Exelon Generation Company, LLC

Braidwood Station, Unit 2
Facility Operating License No. NPF-77
NRC Docket No. STN 50-457

Subject: Response to Request for Additional Information Regarding the Steam Generator
Tube Inspection Report for Braidwood Station, Unit 2, Refueling Outage 17

Response to Request for Additional Information Regarding the Steam Generator Tube Inspection Report for Braidwood Station, Unit 2 Refueling Outage 17

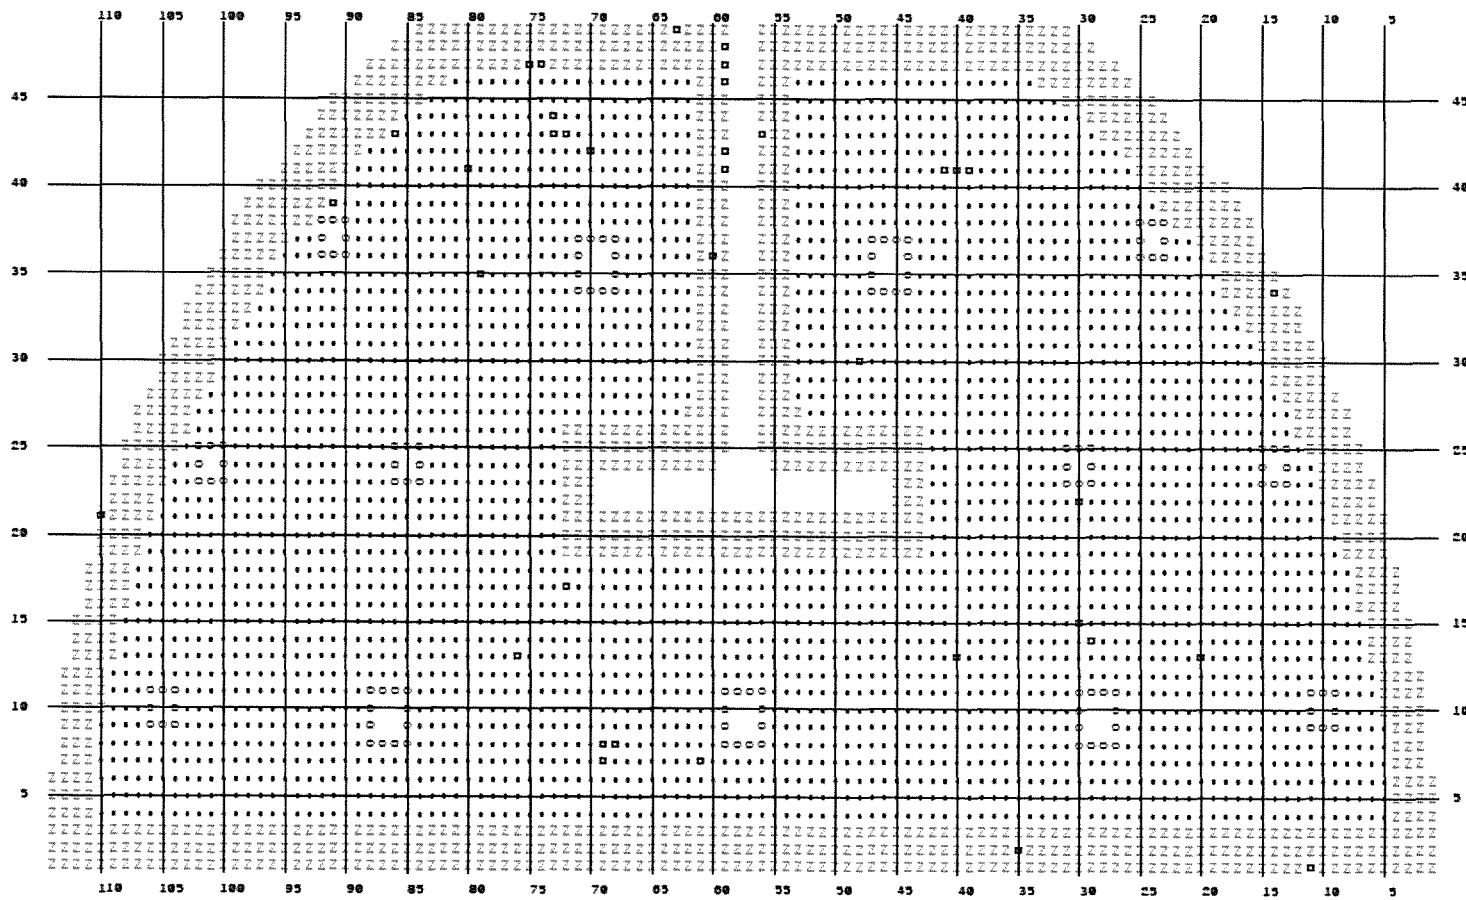
Your November 14, 2014, submittal indicated that three tubes deep around the entire periphery, including the no tube lane and T-slot, were inspected in all four SGs with an X-probe. Clarify the axial extent of these exams (e.g., tube-end to tube-end, H distance to first support on both hot-leg and cold-leg). Discuss whether or not these exams included both hot-leg and cold-leg regions.*

The axial extent was the tube end to flow distribution baffle (1st Tube Support Plate (TSP) -01C or 01H) for the entire periphery scope, including the no tube lane and T-slot. In the "head" of the T-slot on the hot leg, the extent of the exam was extended from 01H to 03H. The exams included both the hot leg and cold leg regions. This is shown in the attached tube sheet maps in Attachment B.
